REMARKS

TITLE: PACING AND SENSING VECTORS
INVENTORS NAME: Jeffrey E. Stahmann et al.
SERIAL NO.: 09/779,754

Fig. 2

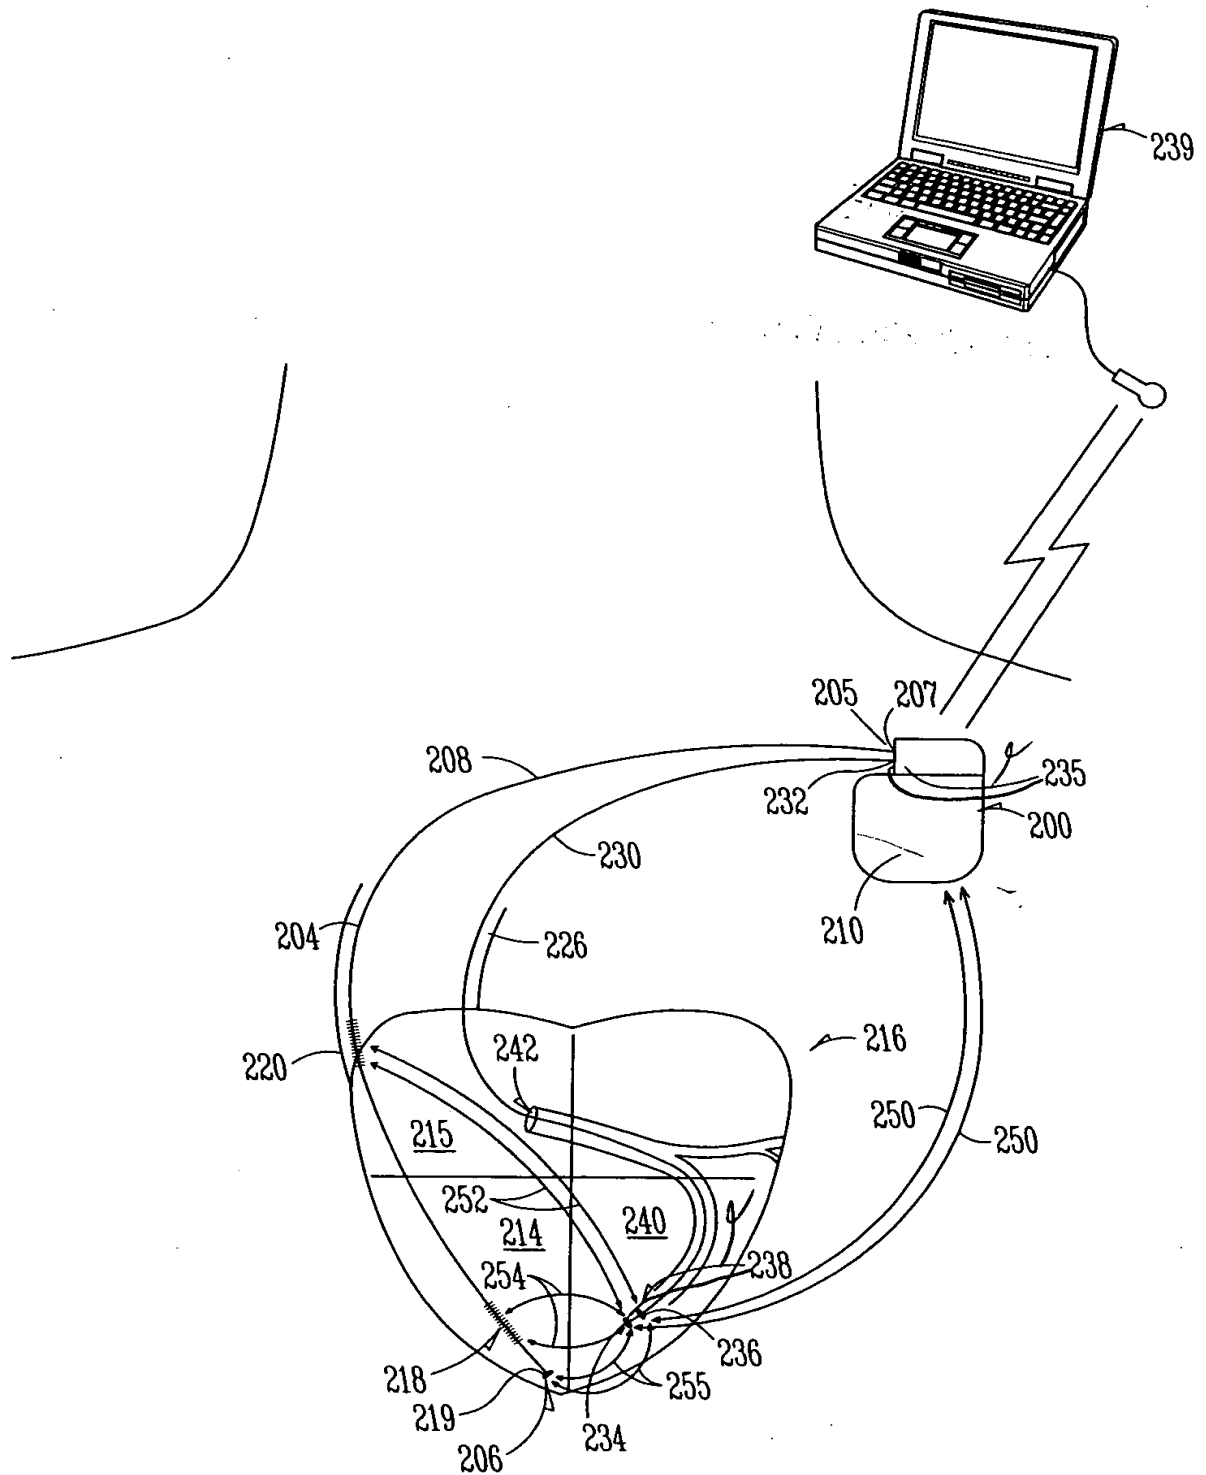
The drawings were objected to under 37 C.F.R. § 1.84(p)(4). The Office Action asserts that, in Figure 2, reference characters "207" and "235" designate the same part. Applicant traverses this assertion, but submits a clarifying drawing change. The patent application uses reference character 207 to refer to a lead connector at a proximal end 205 on a first lead 204.

The Office Action also asserts that, in Figure 2, reference characters "236" and "238" are not clearly marked. Accordingly, Applicant submits a clarifying drawing change. The patent application uses reference character 236 to refer to a first electrode, and uses reference character 238 to refer to a second electrode that may be more distal than the first electrode 236, such as at the distal end 234 of the lead 226. (See Application at page 9, lines 3-10). Applicant believes that this drawing change reflects (and is fully supported by) the specification of the present patent application. Accordingly, Applicant requests withdrawal of this objection.

(See Application at page 7, lines 23-24). The patent application uses reference character 235 to refer to a lead connector at a proximal end 232 of a second lead 226. (See Application at page 8, lines 27-29). Applicant believes that this drawing change reflects (and is fully supported by) the specification of the present patent application. Accordingly, Applicant requests withdrawal of this objection.

Fig. 3

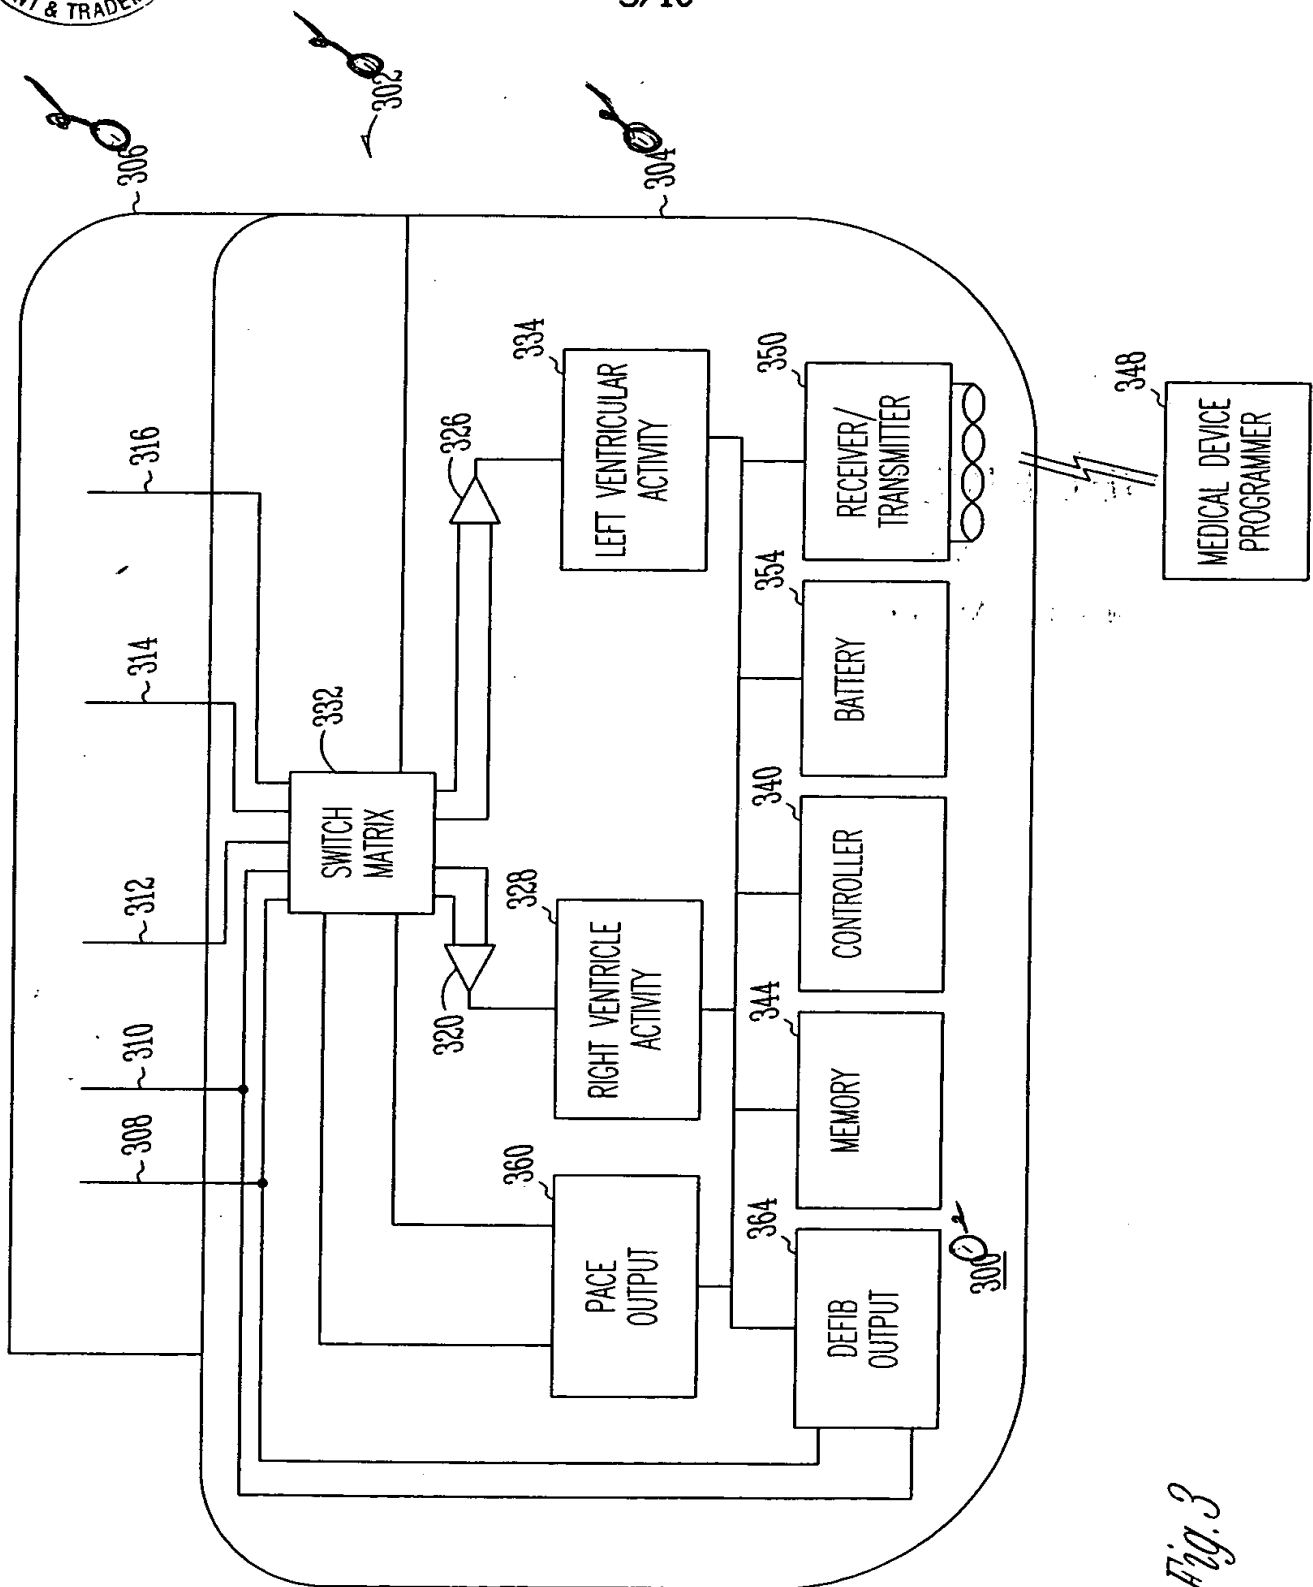
The Office Action also asserts that, in Figure 3, the reference elements 300', 302', 304', and 306' are not mentioned in the description. Accordingly, Applicant submits a clarifying drawing change that removes the "prime" designation on these reference numerals such that they are consistent with (and fully supported by) the specification of the present patent application. Accordingly, Applicant requests withdrawal of this objection.

Fig. 10

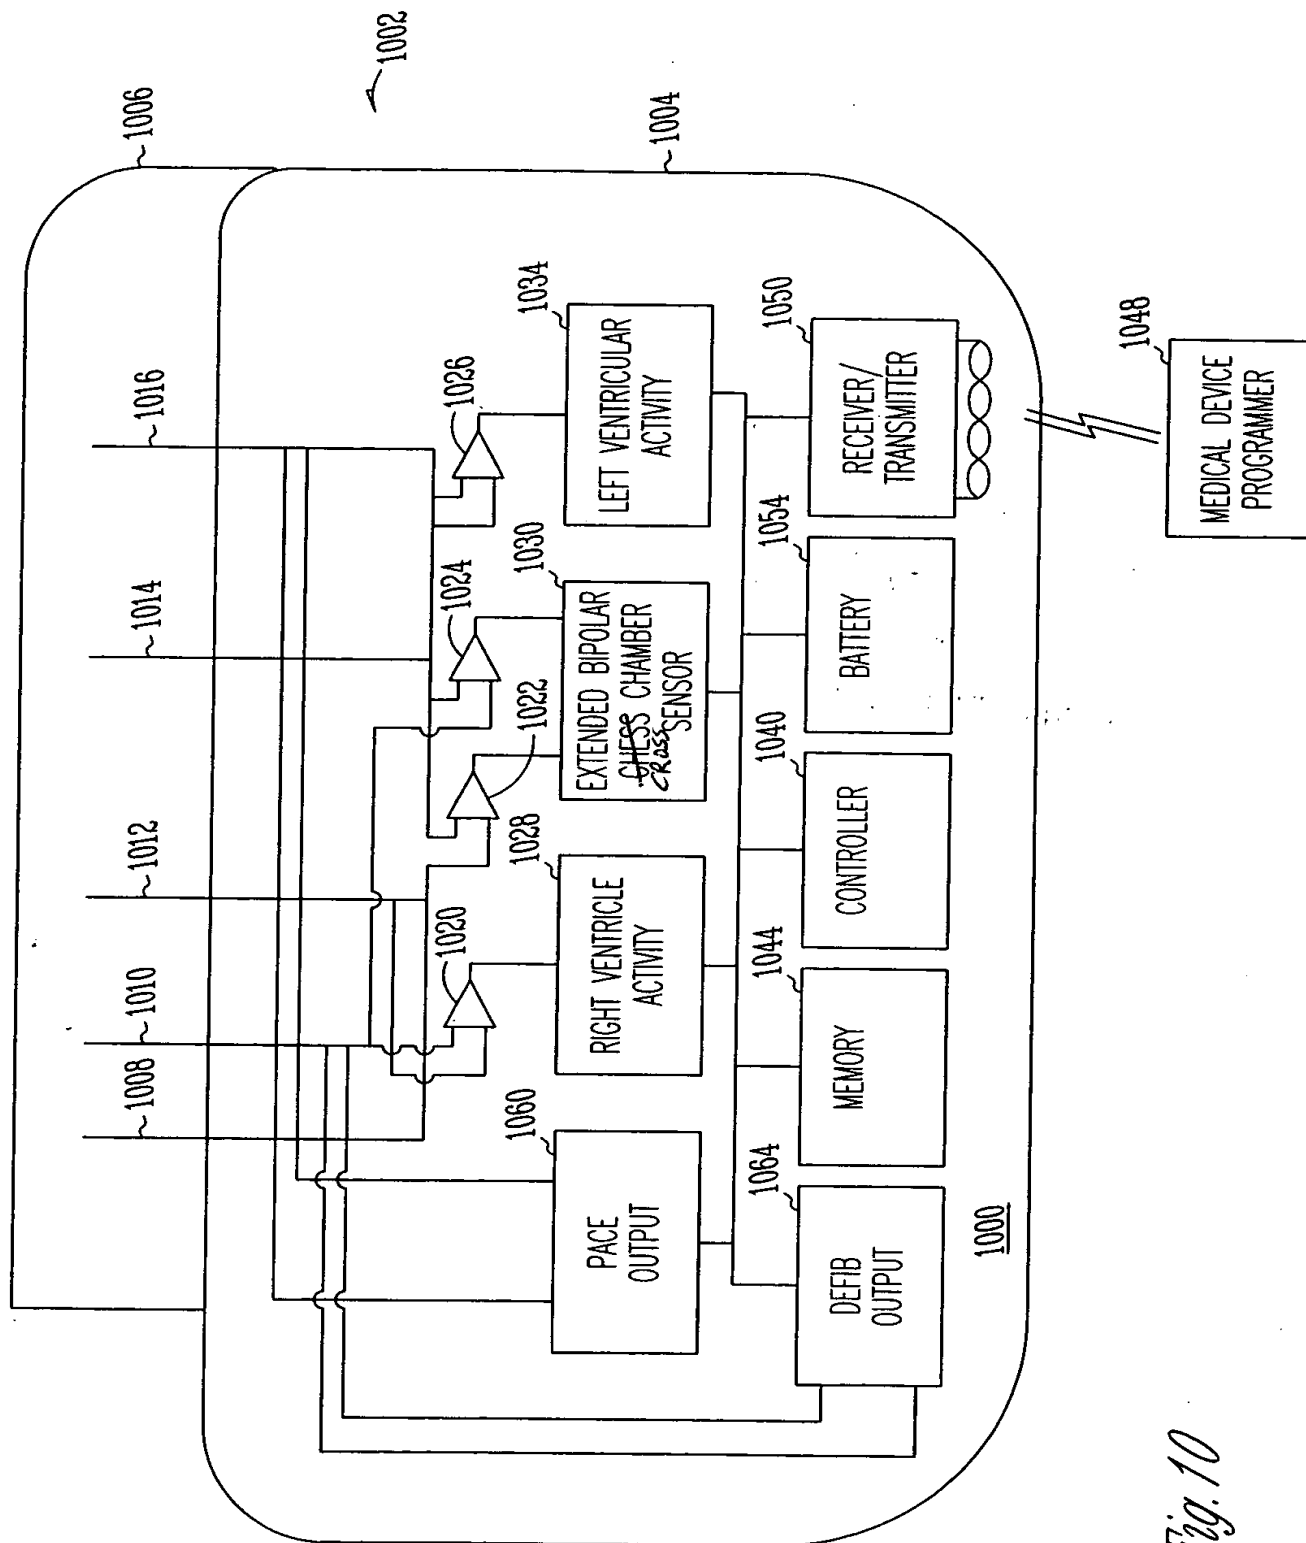
The Office Action also asserts that, in Figure 10, it appears that CHSS should be CROSS. Accordingly, Applicant submits a clarifying drawing change such that Figure 10 is consistent with (and fully supported by) the specification of the present patent application. Accordingly, Applicant requests withdrawal of this objection.
